DWG. 182 - 200	SSEMBLY	ONE INC.																.001 "F						- 11	PAN HEAD TO	DAN HEAD MS	STANDOFF	6-32 x 3/4 HINGED	KEYSTONE 3464	CAMBION 350-1247-11-07		HEX NUT	LOCKWASHER	MICA NEW ATOP	PHILLIPS HEAD MS			1"x 1.2"	T0-5

LNF1-A Amplifier Modifications

Dated March 17, 2009

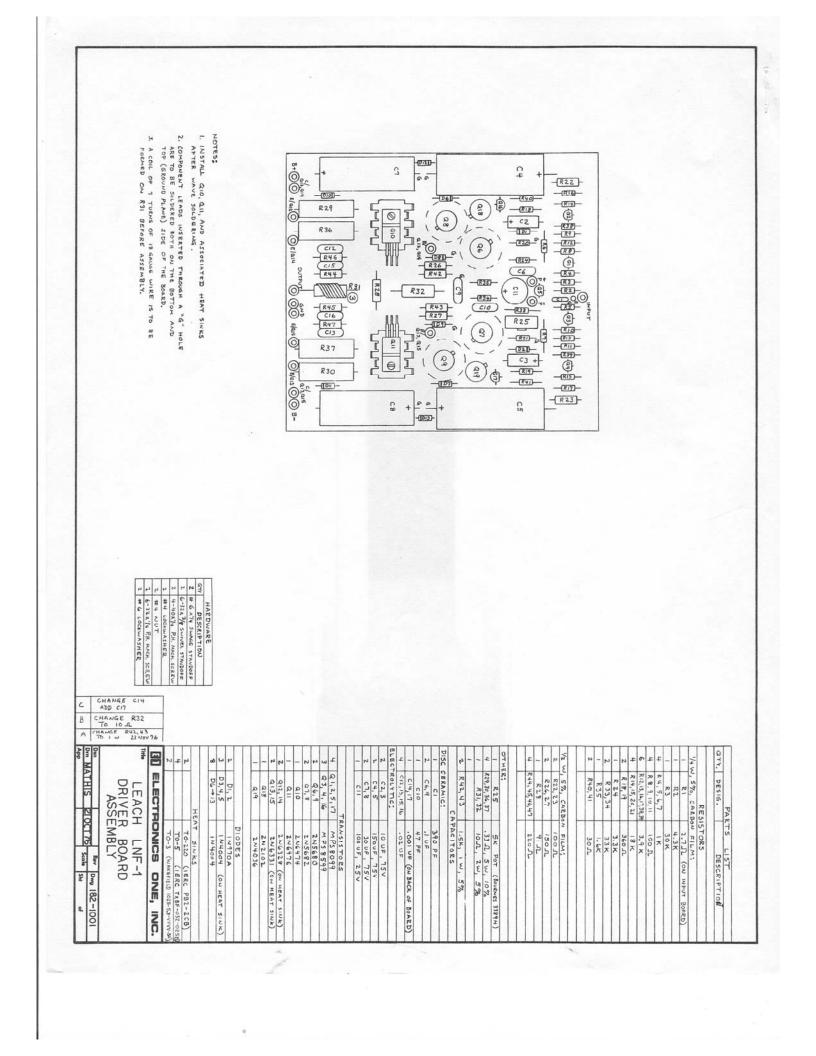
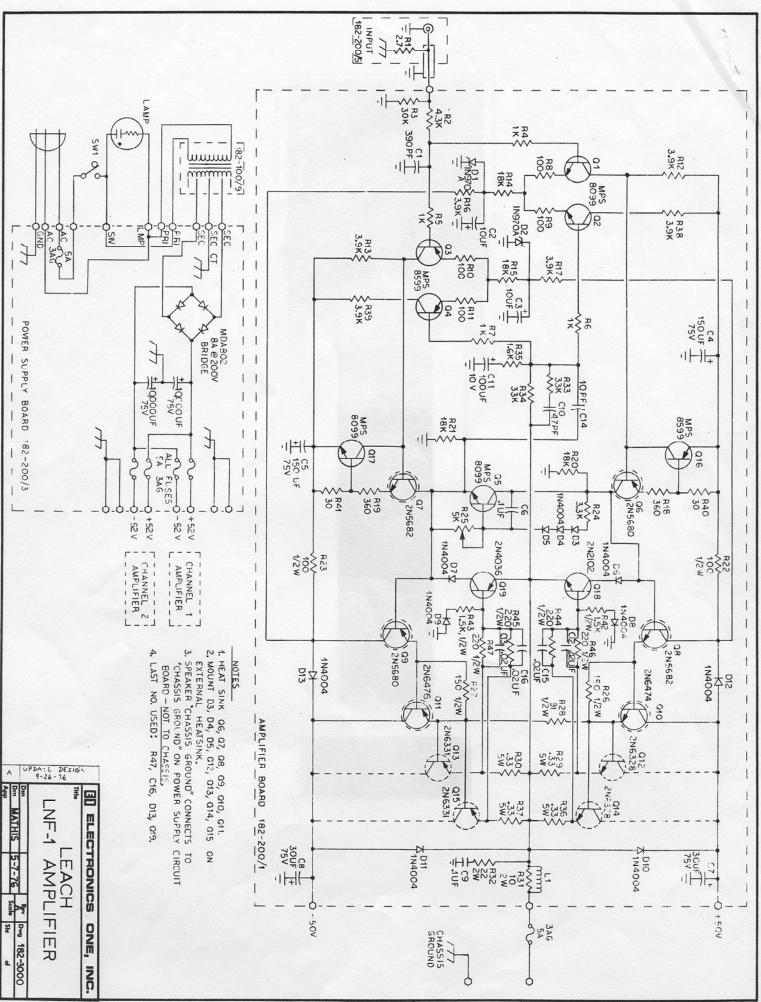
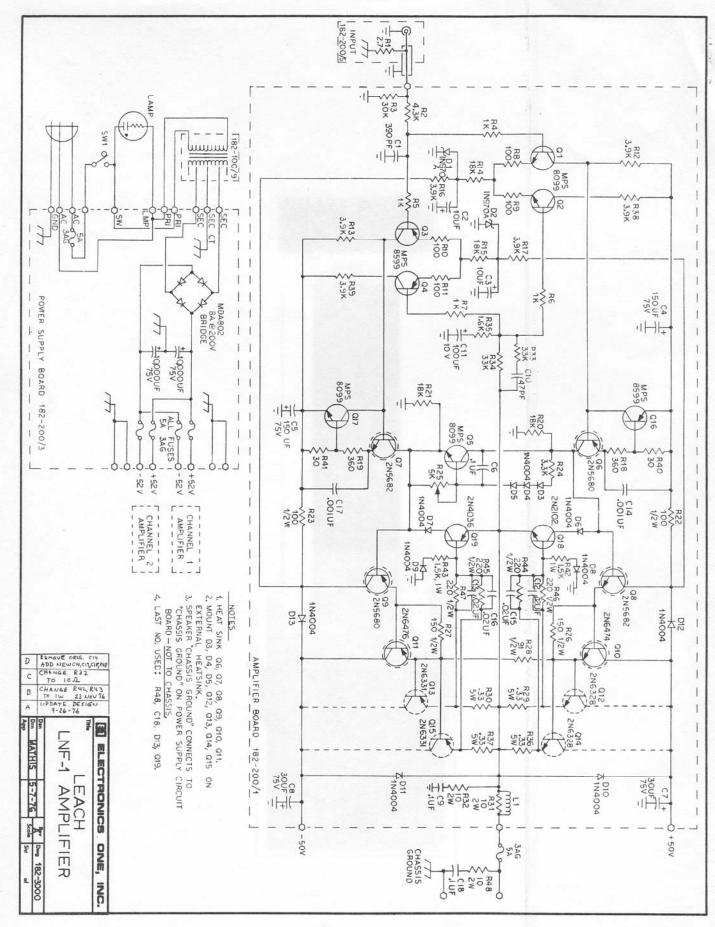
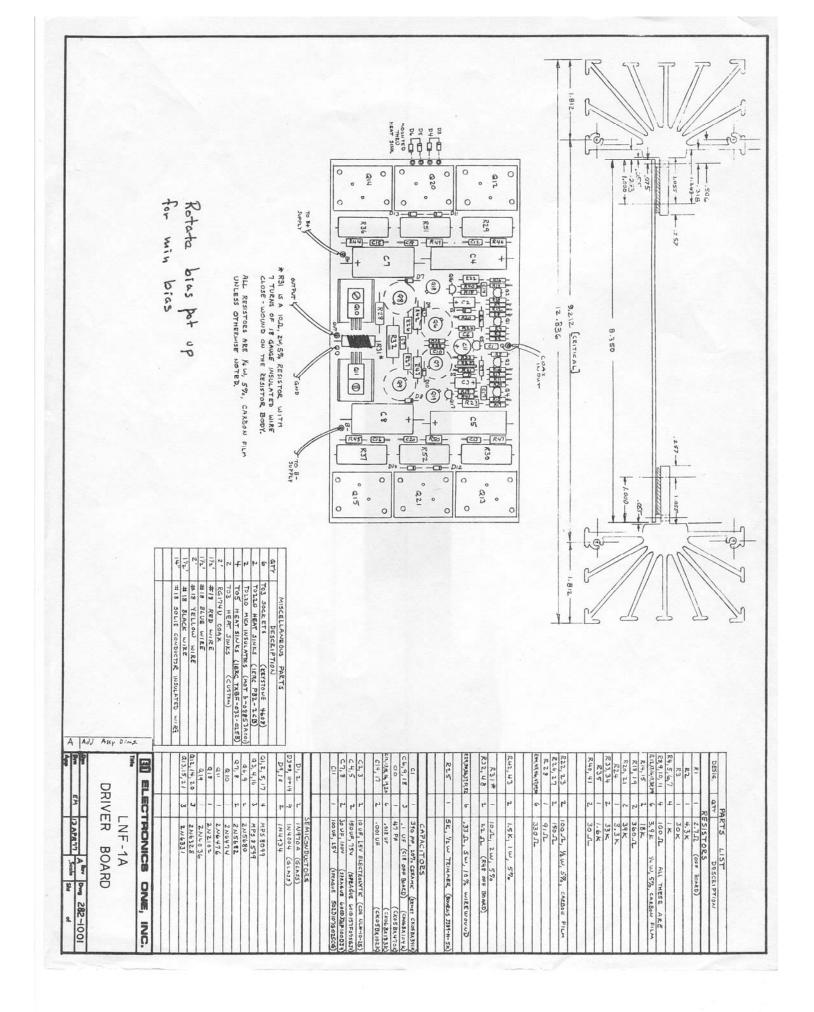
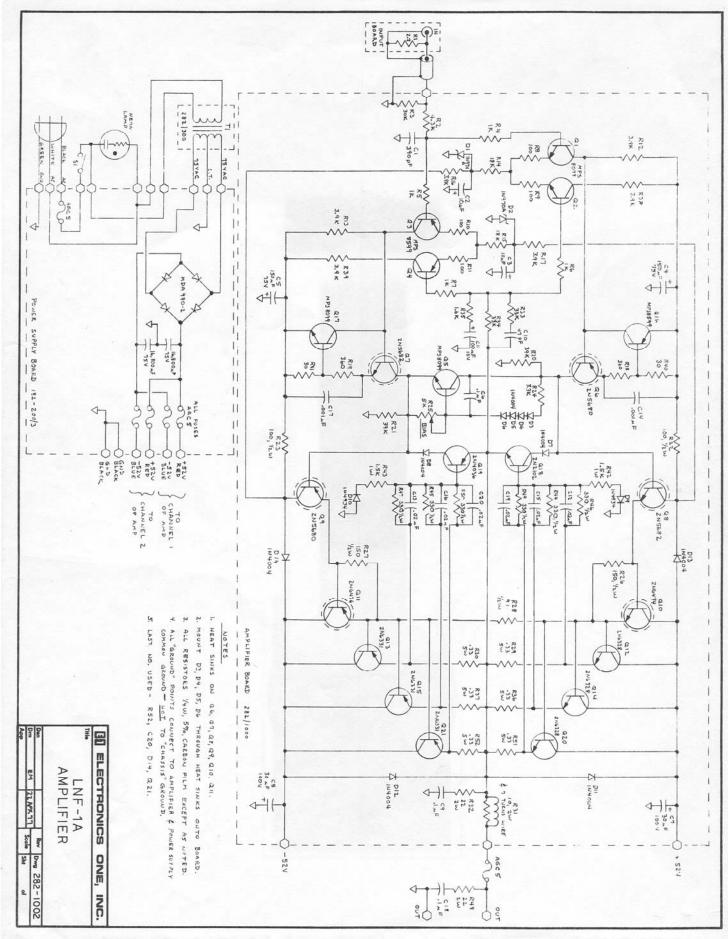
- 1. Clip out R_{20} and R_{21} .
- 2. Clip out R_{33} and C_{10} .
- 3. On drawing 182 100, clip out C_{14} . and C_{15} .
- 4. On drawing 182 3000, clip out C_{14} if present.
- 5. On drawing 282 1002, clip out C_{15} , C_{16} , C_{19} , and C_{20} .
- 6. On drawing 182 3000, clip out C_{15} and C_{16} .
- 7. On drawings 182 3000 and 282 1002, clip out capacitors C_{14} and C_{17}

- 8. Drawing 182 100 shows resistors R_{44} and R_{45} (both 240Ω , 1/4 W) near transistors Q_{18} and Q_{19} . These resistors should be replaced if they are missing. If there are no holes for them on the circuit board, they can be soldered to the backs of the circuit board.

- 9. Add a 10 pF silver mica capacitor from the collector to base of transistors Q_6 and Q_7 . These must be soldered to the backs of the circuit boards.

- 10. As shown on drawing 182 100, C_9 (0.1 F, 100 V) and R_{32} (10 Ω , 2 W) are connected in series across the loudspeaker output binding posts on the rear of the chassis. On some models, this network was moved to the circuit board. If it is on the circuit board, it should be moved to the output binding posts. This is important, for the circuit can oscillate with the network on the circuit board. On drawing 282 - 1002, there is a C_9 (incorrectly labeled C_7) and R_{32} on the circuit board and a R_{48} and C_{18} on the output binding posts. Remove the network on the circuit board and change the values on the output binding post to the correct values. This RC network is to suppress parasitic oscillations. Although I prefer a 10Ω resistor, I believe that a 22Ω resistor is sufficient. But it and the 0.1μ F capacitor must be on the output binding posts.
